Metro Outer Joint Development Assessment Panel Agenda

Meeting Date and Time: Friday, 23 February 2024; 9:30am
Meeting Number: MOJDAP/298
Meeting Venue: Electronic Means

Development Description:	3 Storey Medical Centre w/ Office, Restaurant and Shop
Proposed Amendments:	<ul style="list-style-type: none"> • Modifications to the basement car park. • Reduction in number of on-site parking bays (42 in lieu of 50 previously approved). • Relocation of waste collection to the north-eastern side of the building. • Increased building setbacks to the side and rear boundaries. • Removal of a building entry adjacent to the at-grade carpark on the building's eastern elevation. • Modified pedestrian entry from the Whitfords Avenue frontage. • Reconfiguration of floor areas. • Minor modifications to the building facades.
Applicant:	Extension of time of two years.
Owner:	Jeremy Hofland (Rowe Group)
Responsible Authority:	Citypride Holdings Pty Ltd
DAP File No:	City of Joondalup
	DAP/15/00832

LOT 9 (937) WHITFORDS AVENUE, WOODVALE – EXTENSION OF TIME AND MODIFICATIONS TO MIXED USE DEVELOPMENT

Figure 2 – Proposed Ground Floor Plan

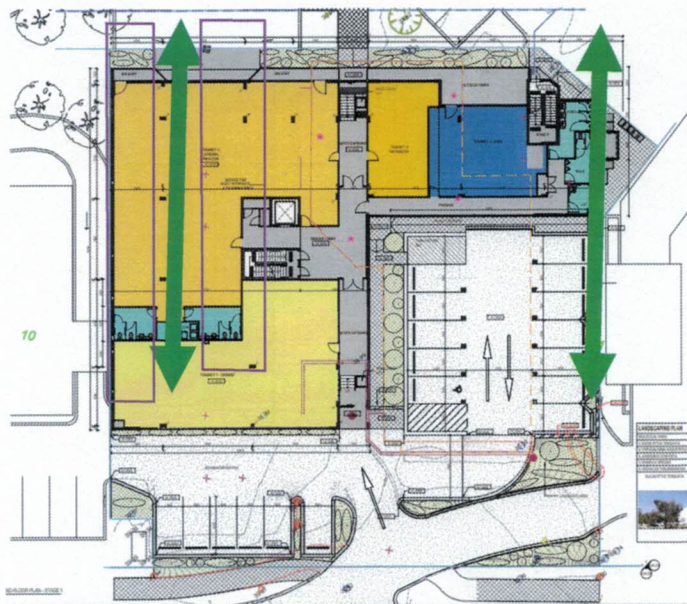
Additionally, the proposal seeks to eliminate two critical vehicle access paths through the site (green arrows in figure 1) and 27 car bays (purple boxes in figure 1) that result in an inability for the customers of the Woodvale Boulevard Shopping Centre to circulate through and utilise.

As can be seen clearly seen on the proposed plan (Figure 2), there is no longer any capacity for the wider curation to work successfully or for parking to be reciprocal. It is noted that the medical centre has been designed to efficiently allow for its customers to park within the Woodvale Boulevard Shopping Centre car park and enter the site – it makes it impossible for the reverse to occur.
